Report No. 9 of the California Independent  
Peer Review Panel (March 6, 2015)

# Independent Peer Review Panel

## IPRP Report No. 9, March 6, 2015

### **Comments on PG&E's Central Coastal California Seismic Imaging Project Report part 3: onshore seismic studies intended to reduce the uncertainty in seismic hazard at Diablo Canyon Power Plant**

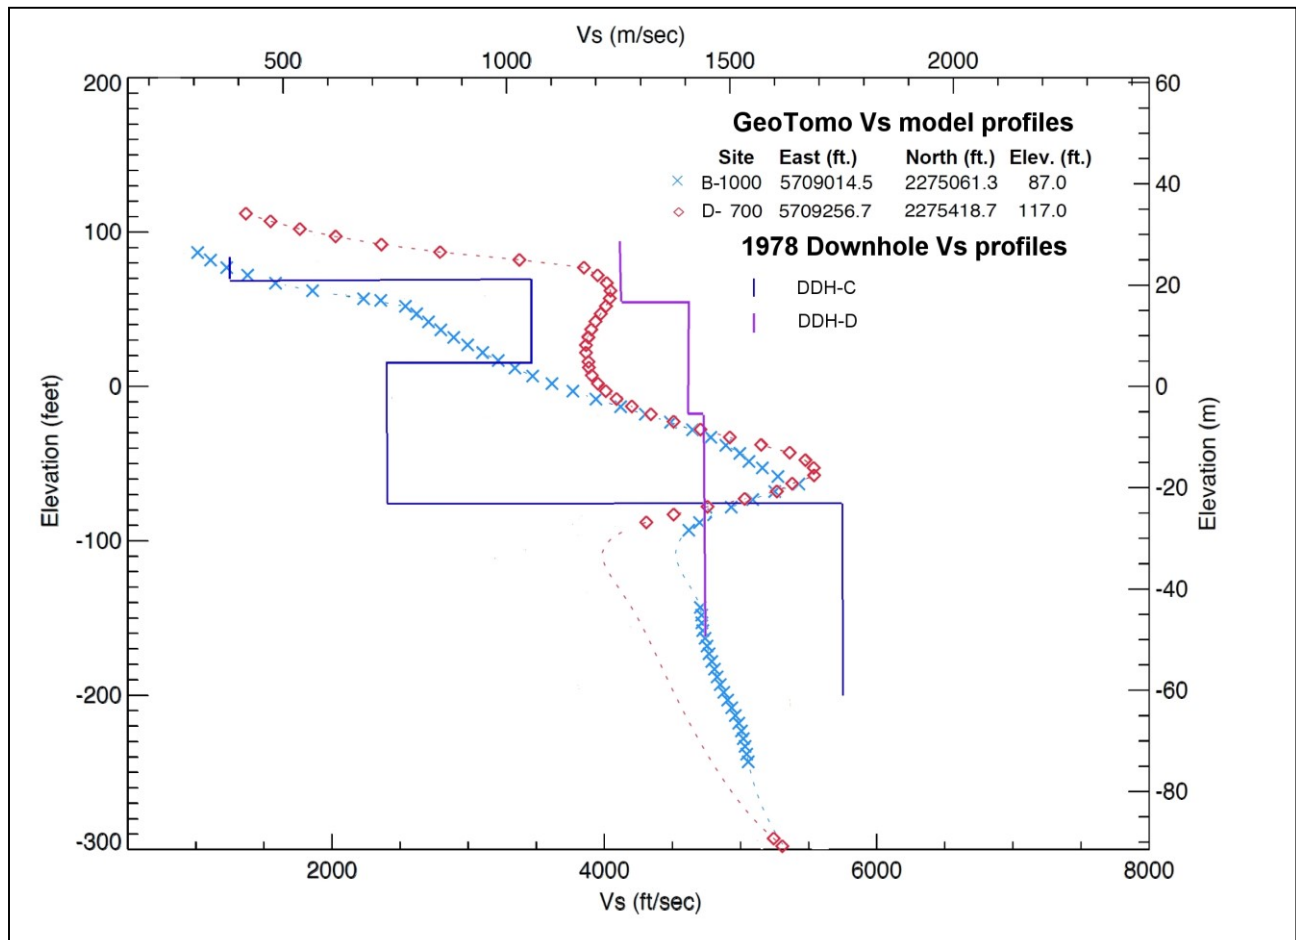
Comparison of  $V_s$  profiles from the tomographic model with profiles measured in 1978 shows broadly similar ranges of  $V_s$  and variation of  $V_s$  with depth. In detail, however,  $V_s$  profiles from the tomographic model do not appear to reproduce the variation in  $V_s$  with depth in nearby measured profiles. The most prominent feature in previous profiles is the high-velocity zone centered at approximately 50' elevation in profile DDH-C (Figure 1). The tomographic model includes a high-velocity zone near this elevation, but not in any of the profiles near the site of profile DDH-C presented on transects B-B' or D-D'. Below the high-velocity zone, profile DDH-C shows lower velocity (731 m/s) but all nearby profiles from the tomographic model show increasing velocity through this zone, reaching velocities of over 1600 m/s in the profile at 1000 ft on transect B-B' (the closest profile to DDH-C presented in the CCCSIP report). Downhole profile DDH-D shows much less variation of  $V_s$  with depth than the nearest profile shown in the CCCSIP report.

Differences between  $V_s$  profiles measured in 1978 and profiles derived from the tomographic model may reflect poor data or poor resolution in the 1978 profiles. If the 1978 downhole velocity surveys represent "ground truth", however, it appears that the tomographic model does not show some shallow high velocity layers up to 50' thick or low velocity layers up to 100' thick. The lack of correspondence between measured  $V_s$  profiles and  $V_s$  profiles estimated from the tomographic model suggests significant uncertainty remains in estimates of "site conditions" at DCP. The IPRP cannot

determine if these differences reflect poor data or analysis in one or both measurements of  $V_s$  or if both surveys are essentially correct, but have differing levels of spatial resolution. Certainly, the differences between  $V_s$  profiles from the tomographic model and previously measured  $V_s$  profiles should have been addressed in the CCCSIP report.

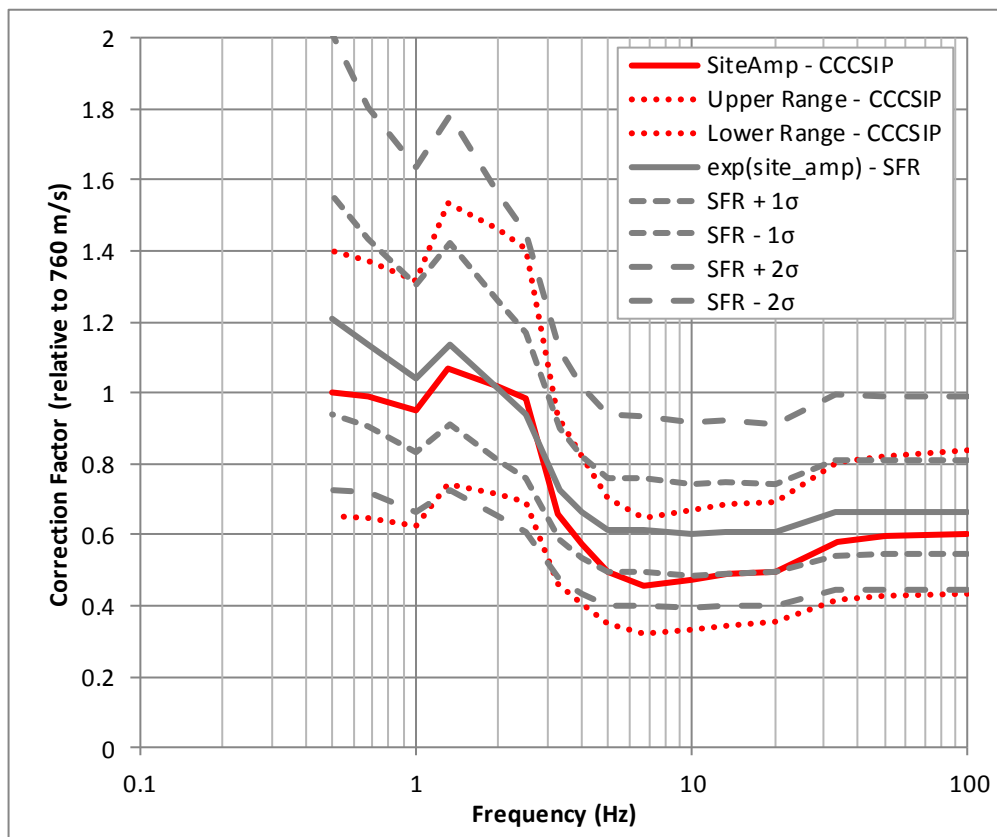
amplification factors for the foundation levels at the power block and the turbine building are listed in Table 3-3, Chapter 11 of the CCCSIP report. Figure 2 compares updated site amplification factors and associated uncertainties in the CCCSIP report with those used in the Shoreline Fault Report. In general, the new factors are slightly lower. However, given large uncertainty in site amplification, the difference should be considered insignificant.

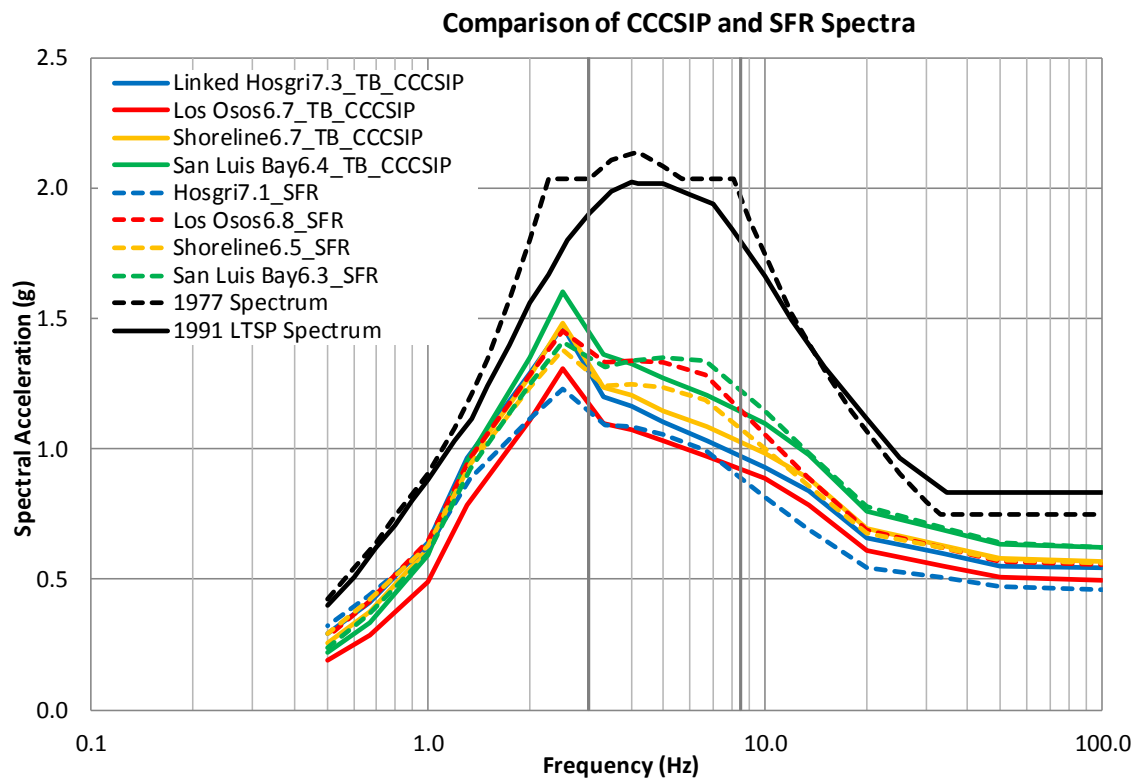
Figure 3 compares deterministic ground motion spectra presented in the CCCSIP report (for the turbine building foundation level,  $V_{S30} = 980$  m/s, solid curves) and the Shoreline Fault Report (for the DCPD site with  $V_{S30} = 1200$  m/s, dashed curves) for the four most important fault sources affecting the DCPD site. The PG&E 1991 LTSP/SSER 34, the 1977 HE (Hosgri Earthquake) design spectrum, and the frequency range important to DCPD structures (marked by vertical dark grey lines) are plotted for reference. Although the CCCSIP updates resulted in different ground motions for individual scenarios, there is little difference in estimated ground motion portrayed by the four scenarios as a group. Ground motion is higher for the linked Hosgri and San Simeon M7.3 scenario compared to the SFR Hosgri M7.1 scenario, except at frequency lower than 1 Hz. The updated Los Osos M6.7 scenario resulted in lower ground motions across the spectrum due to combined effects of the new GMPEs, slightly lower site amplification factors, and steeper minimum dip angle. For the Shoreline and San Luis Bay Fault scenarios, slightly lower ground motions were predicted by the CCCSIP updates for frequency range of 3 to 10 Hz. All scenario spectra fall below the 1991 LTSP and the 1977 HE design spectra. For each earthquake scenario, the CCCSIP deterministic spectrum for the power block foundation level ( $V_{S30} = 1200$  m/s) is slightly lower than the CCCSIP spectra for the turbine building foundation level shown in Figure 3 due to higher  $V_{S30}$  value at the power block foundation level.

**Figure 4. “Tornado Plot” ranking sensitivity of ground motion hazards to uncertainty in input parameters (presented by Norm Abrahamson at the January 8, 2015 IPRP public meeting).**

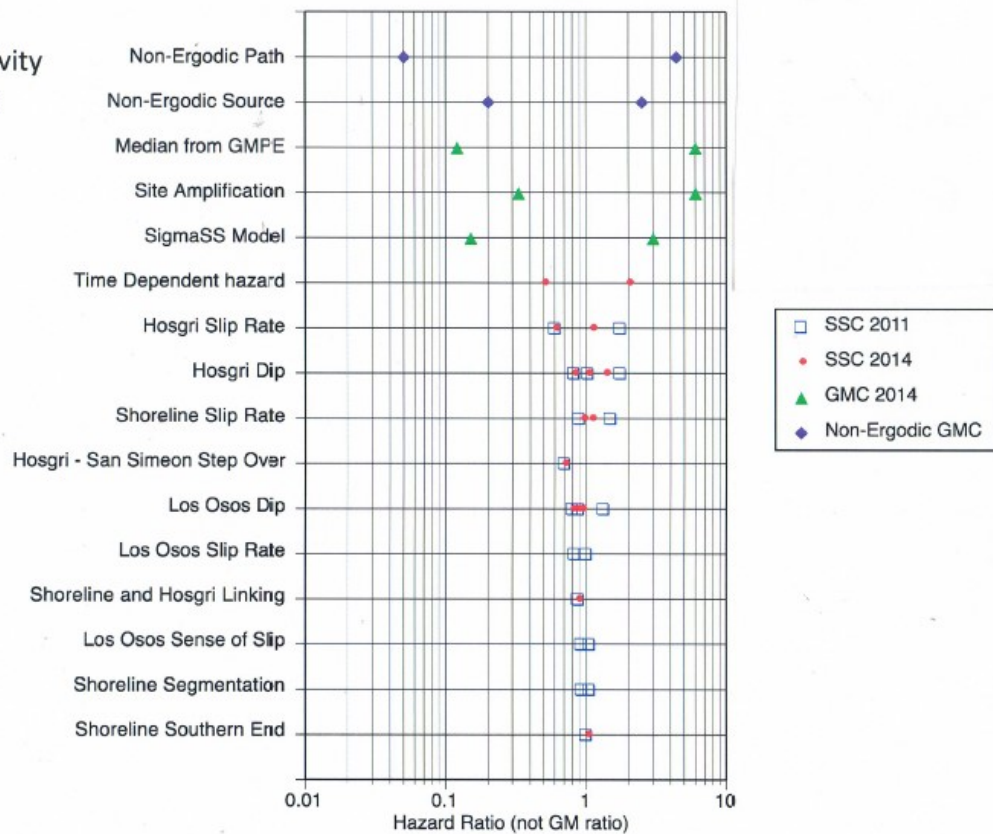
The updated tornado plot illustrates the reduction of uncertainties in some source parameters based on information developed by the AB1632 studies as reported in the CCCSIP. We note that uncertainty reductions shown in the updated tornado plot is based on PG&E's updated PSHA analyses as part of the SSHAC process. IPRP has not reviewed these new calculations and cannot comment on whether the reductions seen on the updated tornado plot are reasonable.

The most striking feature of this updated tornado plot is the 6 items related to ground motion calculation on the top of the tornado that have considerably greater uncertainty and hazard sensitivity compared to the source parameters (lower part of the tornado starting from Hosgri slip rate). The IPRP previously recognized the importance of ground motion calculation parameters (including site specific amplification and ground

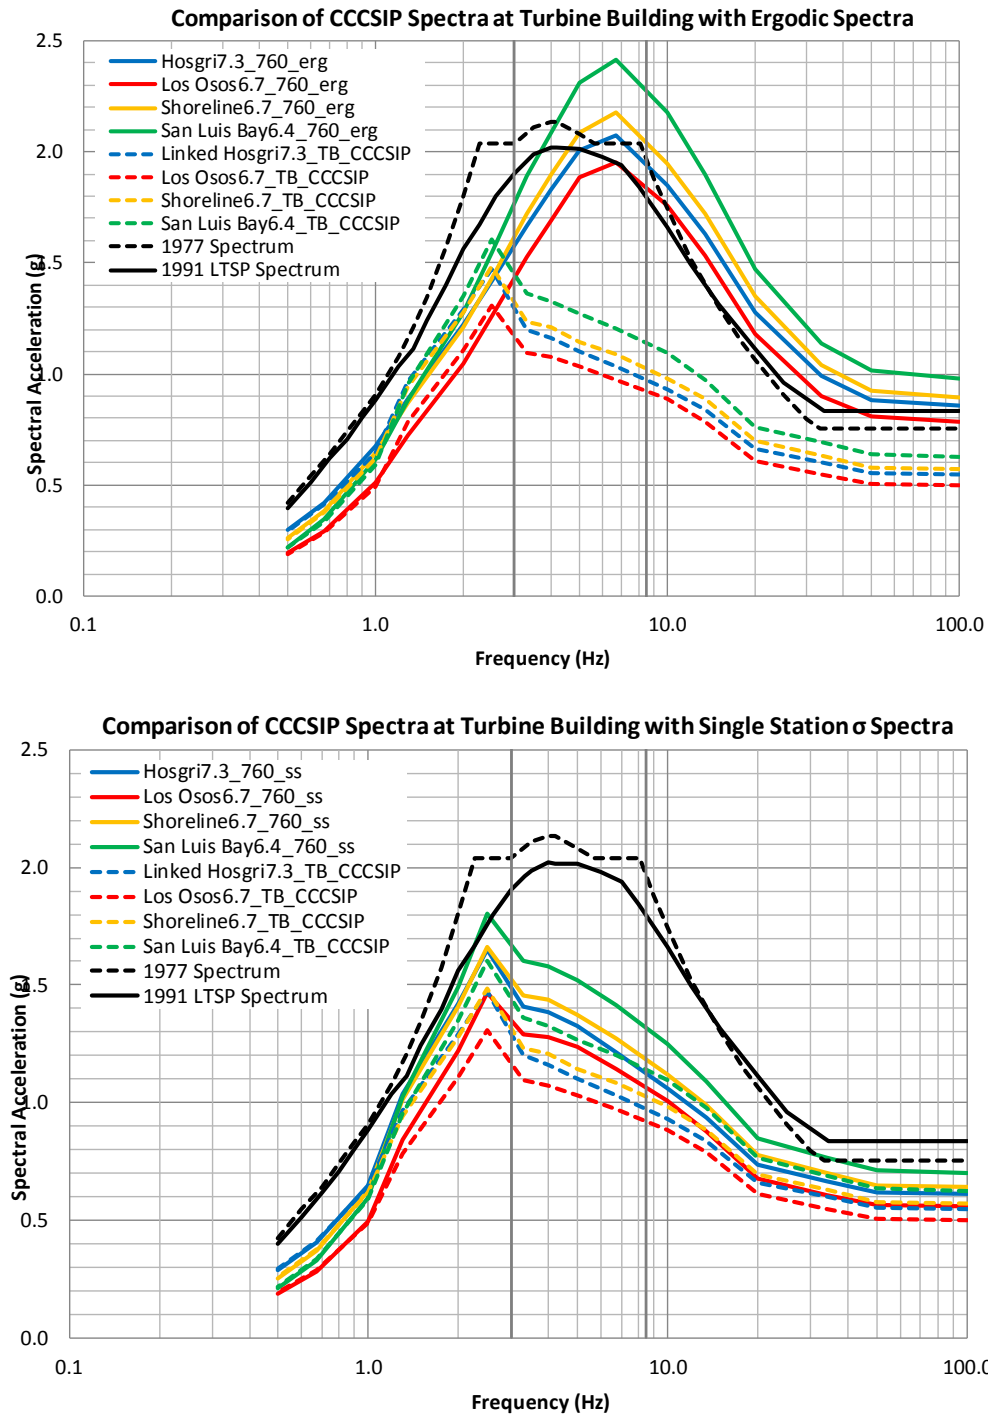
Figure 5a shows that the deterministic spectra calculated based on the ergodic assumption exceed the 1977 HE and the 1991 LTSP spectra for all but one scenarios in the period range important to DCPD, which re-illustrates observations made in the IPRP Report No. 6 and depicted in Figure 7c of that report. Scaling of  $V_{S30}$  from 760 m/s to 980 m/s decreases deterministic ground motion across the spectrum, except for frequencies less than 1 Hz (Figure 5b). Differences between the  $V_{S30}$  of 760 m/s cases (solid curves) shown in Figures 5a and 5b reflect differences when ergodic assumption is used (Figure 5a) versus when single station sigma with site specific term is used (Figure 5b). For the DCPD site, the use of single station sigma with site-specific term appears to be the key factor that brings the deterministic spectra below the original design spectra.

While the single station sigma assumption and especially the site term have a significant effect on hazard, the site term is based on the observations of only two earthquakes. As described in IPRP Report No. 6, the IPRP is not convinced that the “site term” reflects some property of the site that would affect all earthquakes recorded at DCPD. The alternative hypothesis that additional factors related to the particular source or paths of those two earthquakes remains at least as plausible. The CCCSIP report does not include any additional studies to address this issue. The 3D site response analyses proposed by PG&E will not address whether single station sigma model is more reasonable than the ergodic assumption, nor will it reduce uncertainty in the site specific term that is calculated based on two recorded earthquakes. The proposed 3D site response model will address  $V_{S30}$  scaling and the effect of large variability in  $V_{S30}$  values at the DCPD site.

**Figure 6. Comparison of deterministic ground motion spectra for the Shoreline Fault rupture linked with the Hosgri and San Simeon Faults.**

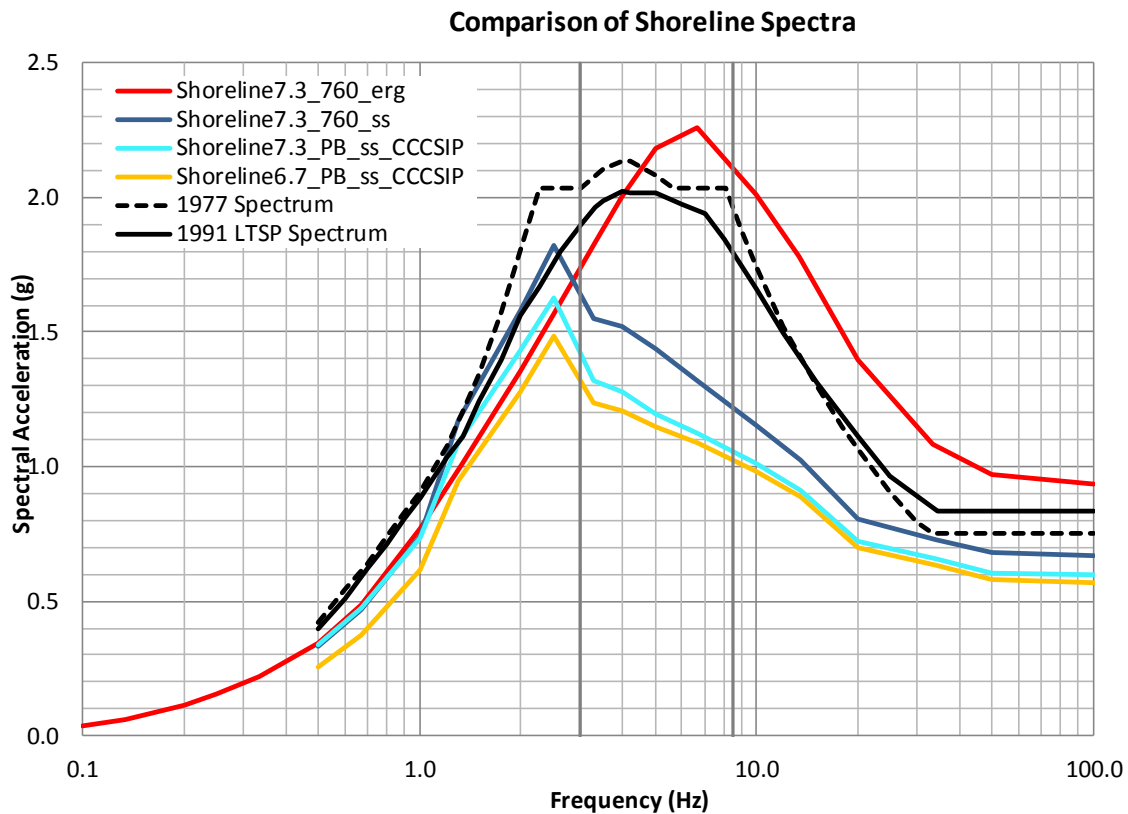
Figure 6 compares deterministic spectra for the CCCSIP sensitivity scenario assuming linked co-seismic rupture of the Shoreline, Hosgri, and San Simeon Faults (M7.3). It shows that deterministic ground motion increases across the spectrum as magnitude for the Shoreline Fault rupture increases from 6.7 to 7.3. This figure also shows increased ground motion as  $V_{S30}$  decreases from 1200 m/s [at the power block foundation level] to 760 m/s. More significantly, the figure shows, once again, that the most influential factor affecting deterministic ground motion estimates is the single station sigma assumption and the site term.
